Bid Bulletin #04

PROJECT: Weeping Water Public Schools
Additions & Renovations
Weeping Water, NE

RE: Addendum No. 3 to the Bidding Documents for:
Weeping Water Public Schools
Additions & Renovation
204 West O Street
Weeping Water, Nebraska 68463
Schemmer Project No. 06368.001

DATE: 02/18/14	DRAWN: JVR	SCALE: As indicated	SHEET NO: SDM-15
SHEET TITLE: STORM SHELTER PENETRATIONS			REF: M1-02

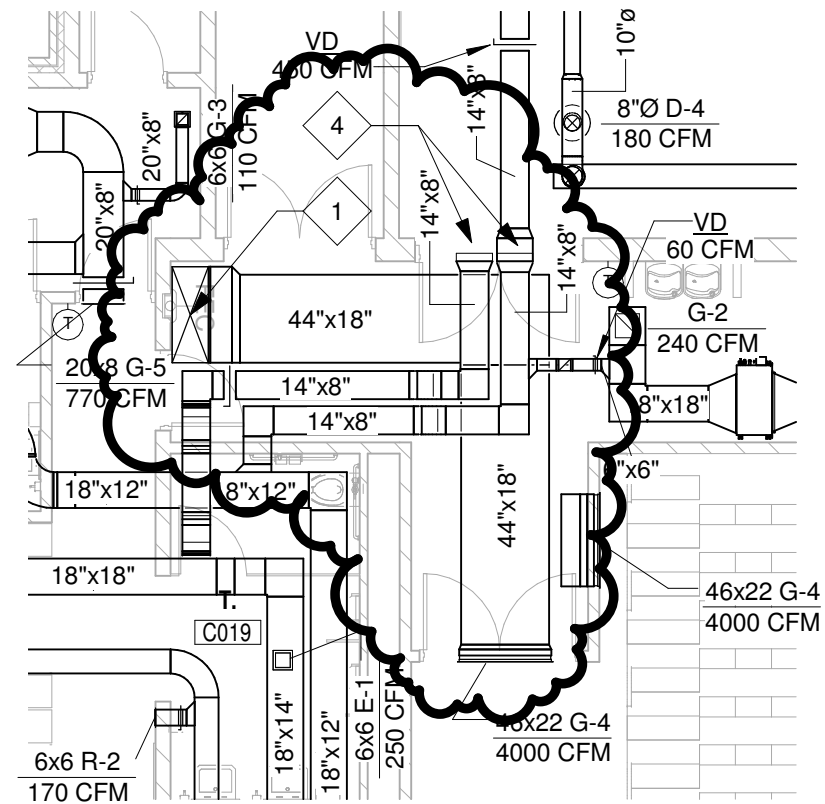
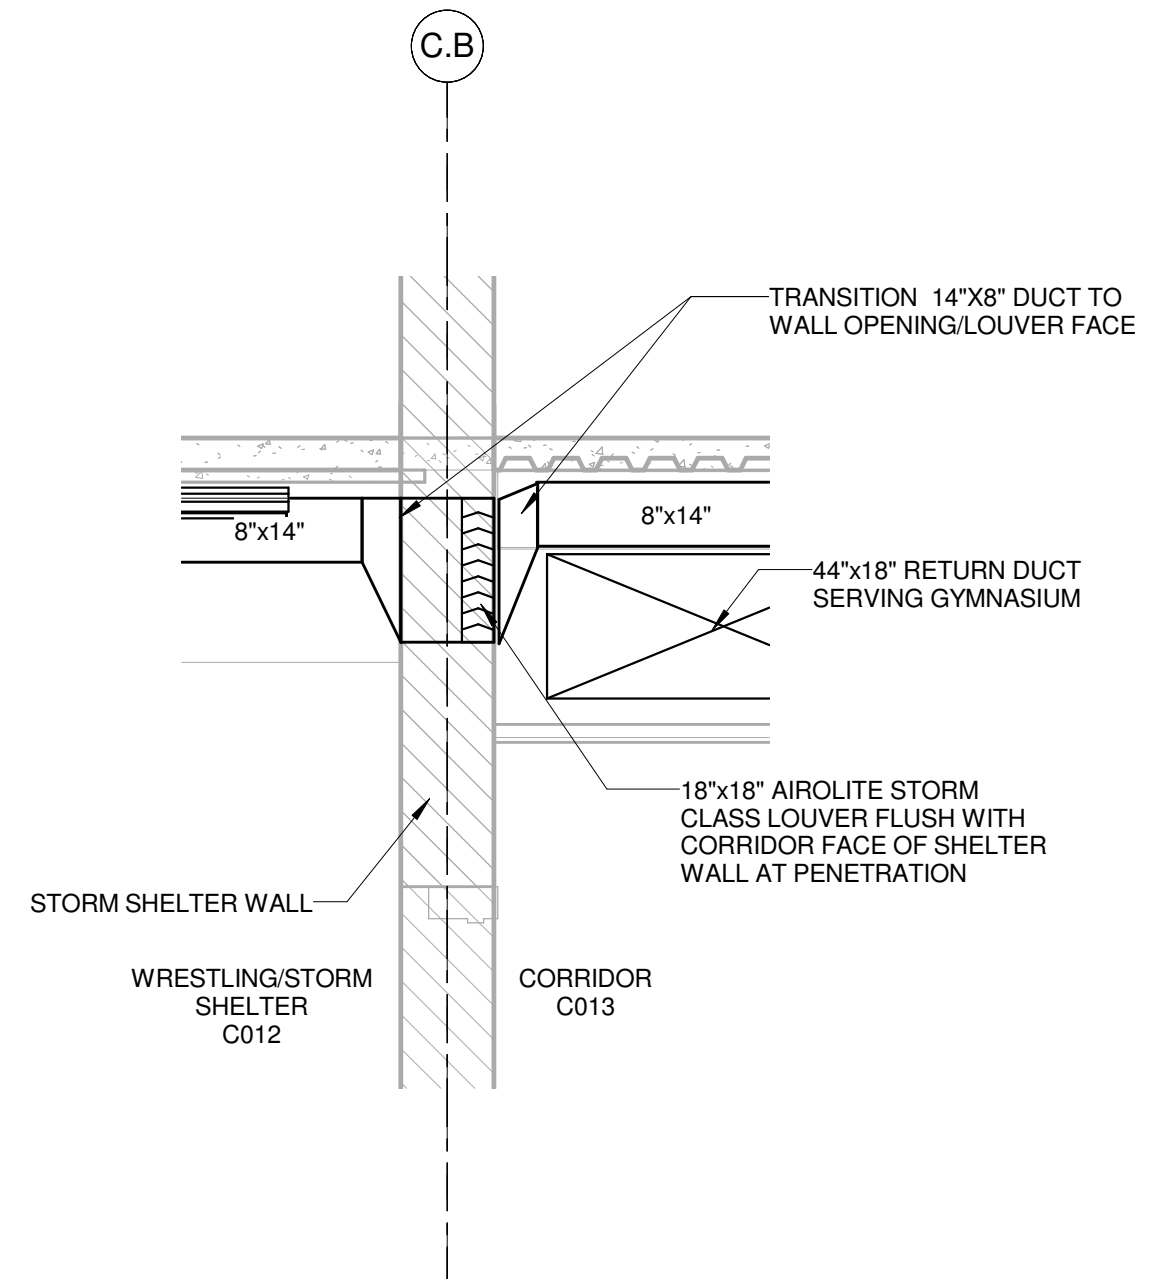
- 1) Plan updated to indicate storm class louvers in duct penetrations through shelter wall: reduce 48x18 return duct serving gym to 44x18 to provide space for 14x8 to 18x18 transitions for ducts penetrating shelter wall; see supplemental drawing SDM-15.

- 48"x18" RETURN DUCT UP THROUGH CHASE ABOVE. SEE SHEET M1-03 FOR CONTINUATION.
- HIGH WALL DUCTLESS SPLIT SYSTEM INDOOR UNIT RELOCATED FROM ROOM SECRETARY A101A TO BE INSTALLED ABOVE DOOR IN THIS SPACE. LOCATE ON ROOF ASSOCIATED OUTDOOR UNIT RELOCATED FORM AREA A ROOF. SEE SHEETS M1-03, M1-09, AND M2-03 FOR ADDITIONAL INFORMATION.
- 18"x18" OUTDOOR AIR AND EXHAUST AIR DUCT UP THROUGH CHASE IN FREEZER C177 TO ERV-5 ON ROOF. SEE SHEET M1-03 FOR CONTINUATION.
- 18"x18" AIROLITE SCH401 STORM CLASS LOUVER OR EQUAL; 0.70 SQ.FT. MINIMUM FREE AREA. TRANSITION 14"x8" DUCTS TO WALL OPENING.

DATE: 02/21/14 DRAWN: JVR SCALE: As indicated SHEET NO: SDM-16

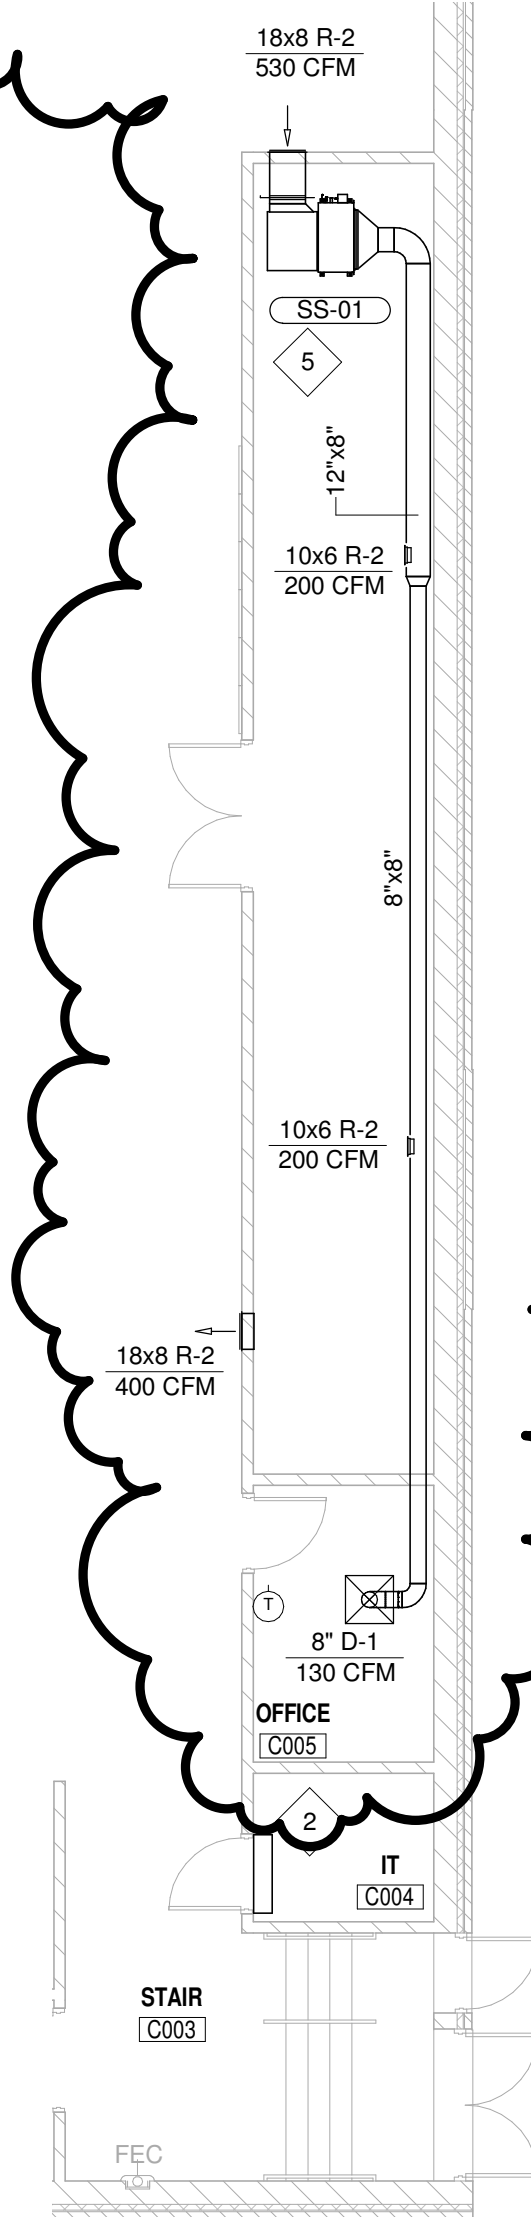
- 1) Fan coil unit FC-79 serving storage room and Office C005 revised from VRF system to a mini split system comprised of indoor unit SS-01 and outdoor unit SSHP-01; see supplemental drawings SDM-16 and SDM-19 for new plan and schedule information.

1. 48"x18" RETURN DUCT UP THROUGH CHASE ABOVE. SEE SHEET M1-03 FOR CONTINUATION.
2. HIGH WALL DUCTLESS SPLIT SYSTEM INDOOR UNIT RELOCATED FROM ROOM SECRETARY A101A TO BE INSTALLED ABOVE DOOR IN THIS SPACE. LOCATE ON ROOF ASSOCIATED OUTDOOR UNIT RELOCATED FORM AREA A ROOF. SEE SHEETS M1-03, M1-09, AND M2-03 FOR ADDITIONAL INFORMATION.
3. 18"x18" OUTDOOR AIR AND EXHAUST AIR DUCT UP THROUGH CHASE IN FREEZER C117 TO ERV-5 ON ROOF. SEE SHEET M1-05 FOR CONTINUATION.
4. 18"x18" AIROLITE SCH401 STORM CLASS LOUVER OR EQUAL, 0.70 SQ.FT. MINIMUM FREE AREA. TRANSITION 14"x8" DUCTS TO WALL OPENING.
5. LOCATE SPLIT SYSTEM HEAT PUMP (SSHP-01) SERVING SPLIT SYSTEM FAN COIL UNIT (SS-01) ON GYMNASIUM ROOF.

SHEET NO: SDM-17

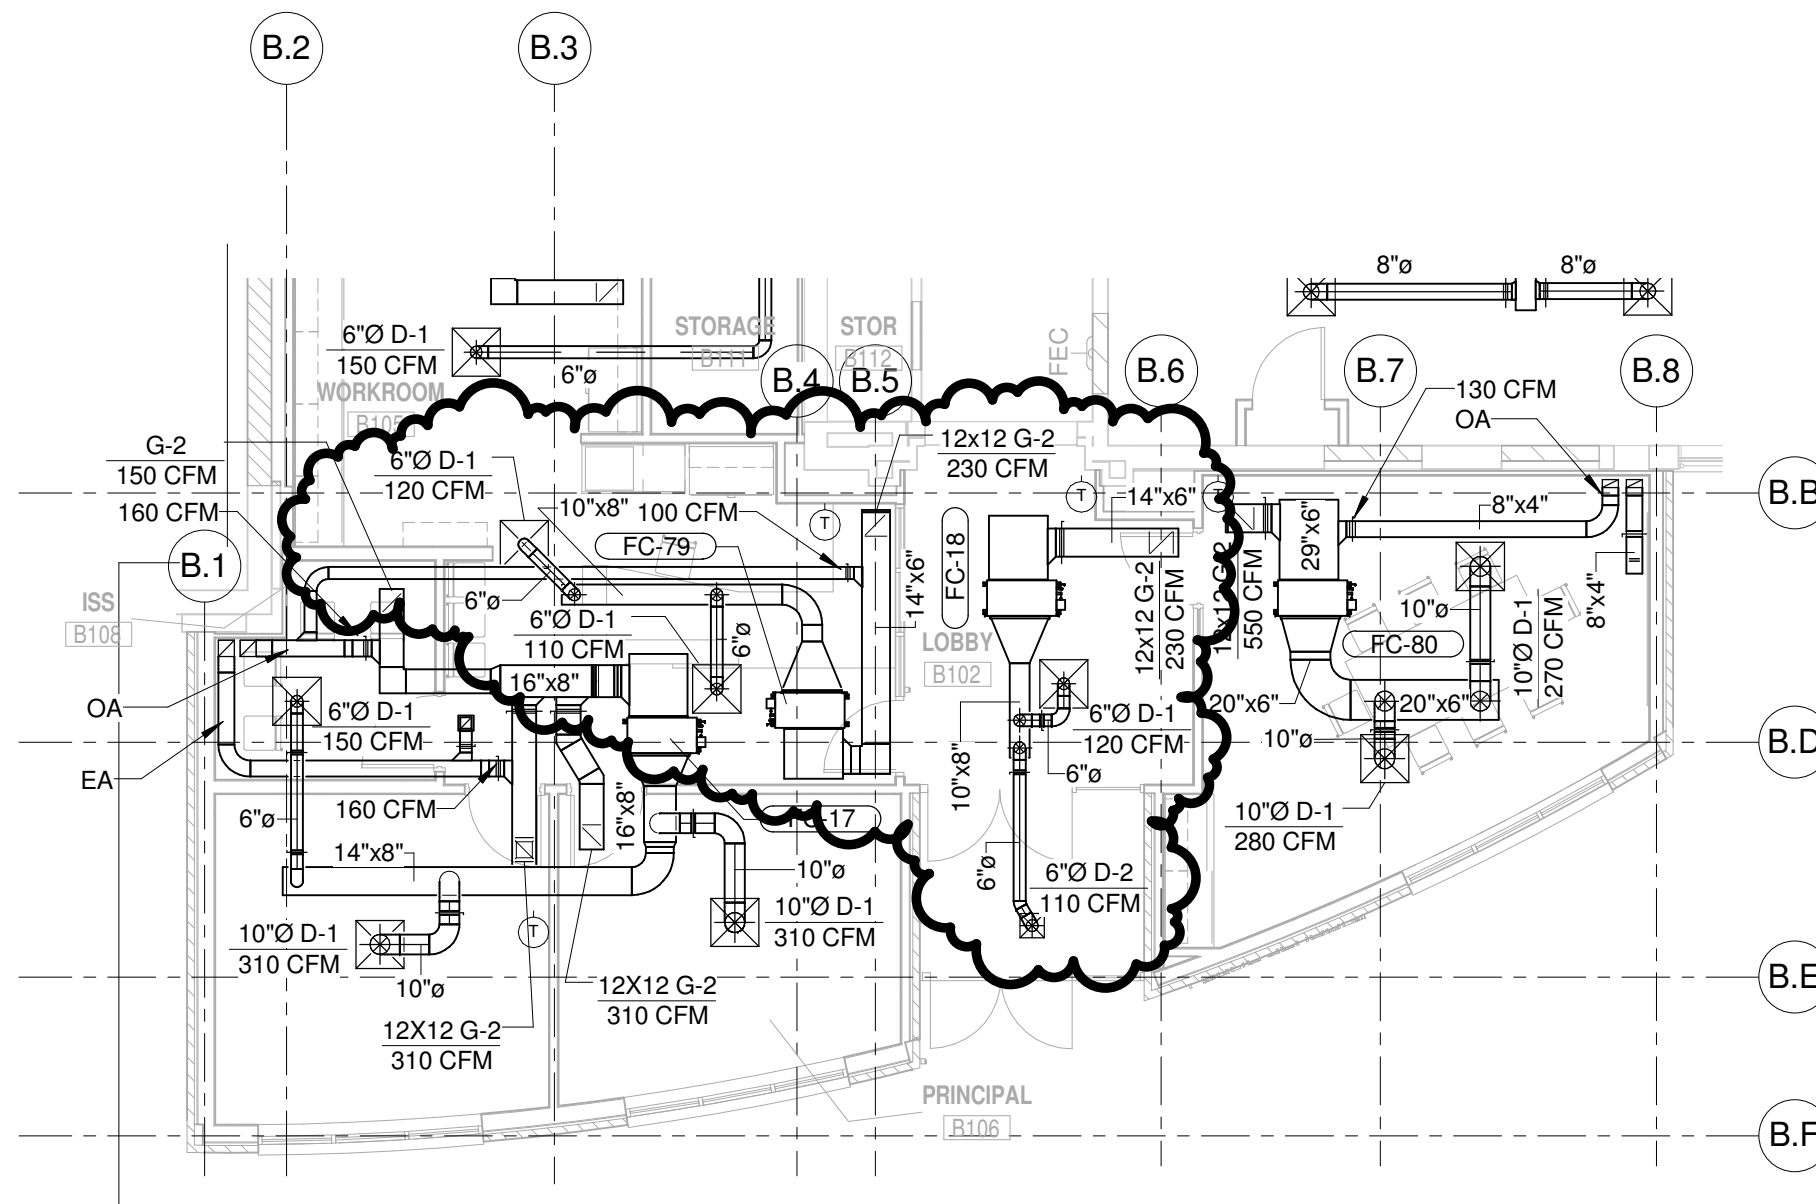
- 1) Fan coil FC-18 unit size reduced and distribution isolated to Lobby and Vestibule to comply with egress fire separation requirement. Fan coil added to Workroom and given the tag FC-79 (See DM-2 above); see supplemental drawings SDM-17 and SDM-19 for new plan and schedule

SHEET NO: SDM-18

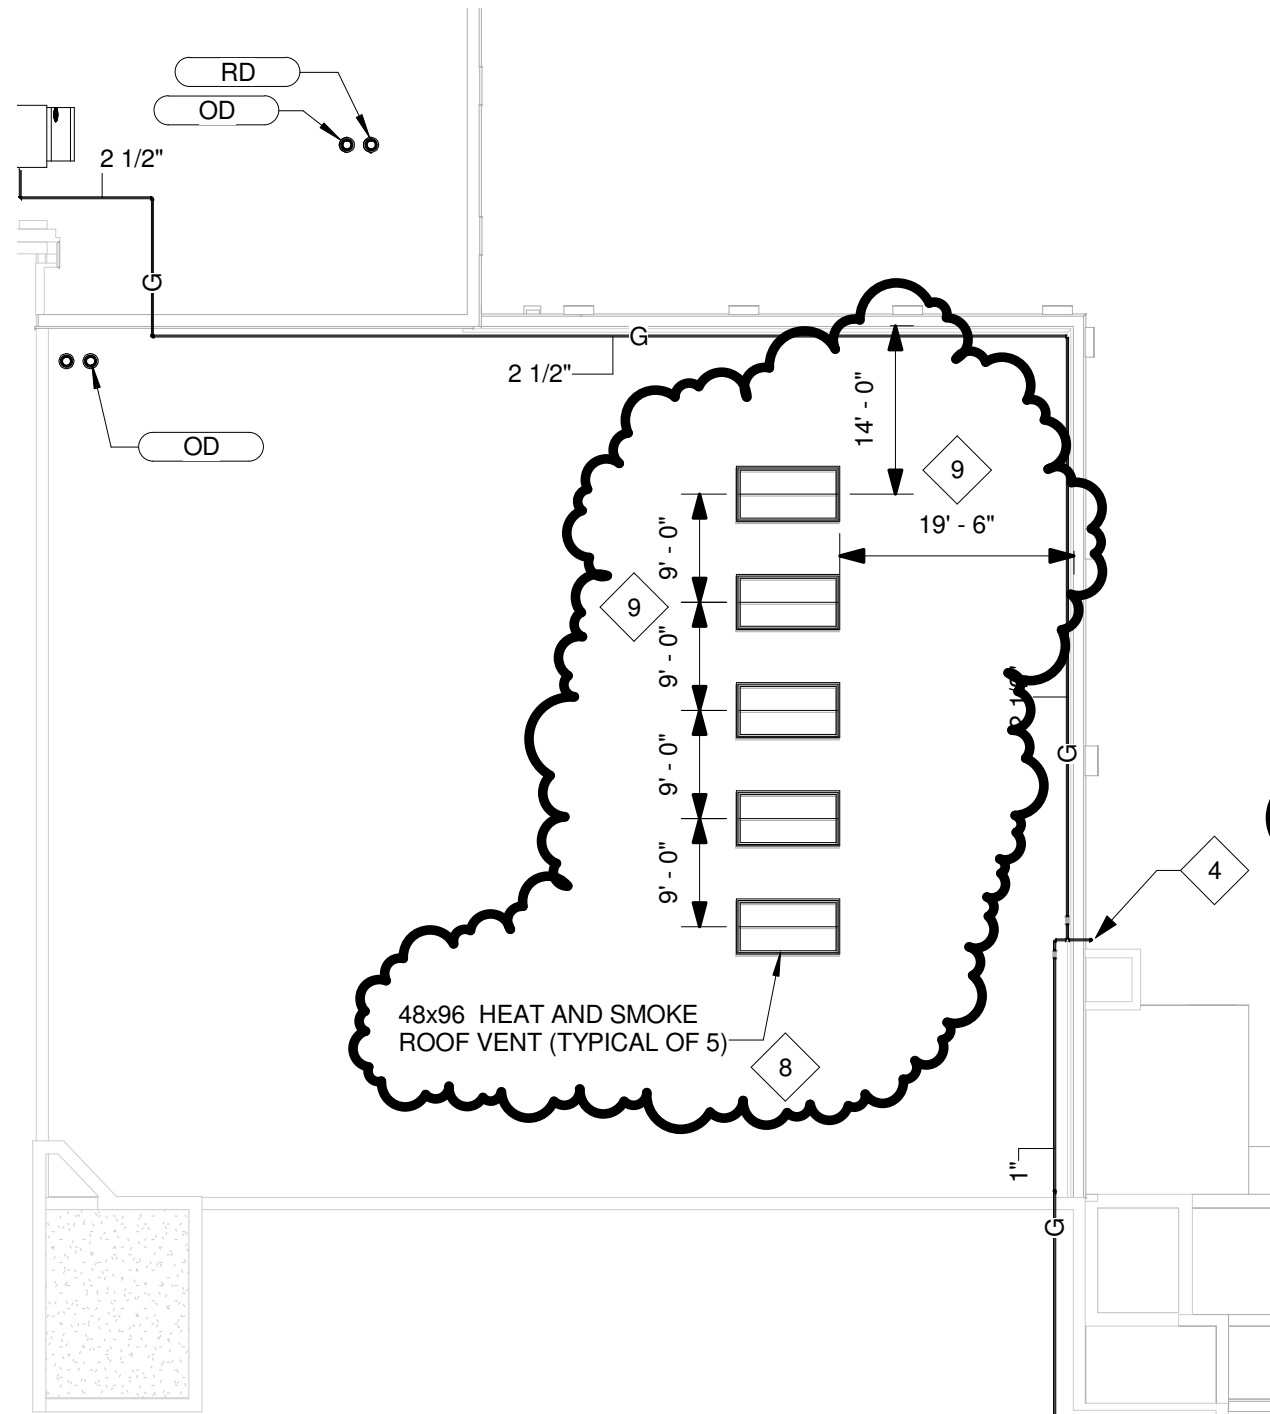
- 1) Roof plan updated to include heat and smoke vents above stage area at Auditorium in Area A; see supplemental drawing SDM-18.

8. HEAT AND SMOKE VENTS SHALL BE EQUAL TO BILCO 48"X96" DOUBLE LEAF AUTOMATIC FIRE VENT WITH THERMOLATCH ELECTRIC ACTUATOR OPTION.
9. LOCATION AND SPACING APPROXIMATED; ADJUST AS NECESSARY TO COORDINATE WITH EXISTING STRUCTURE BELOW. FIELD VERIFY EXISTING STRUCTURE PRIOR TO CONSTRUCTION.
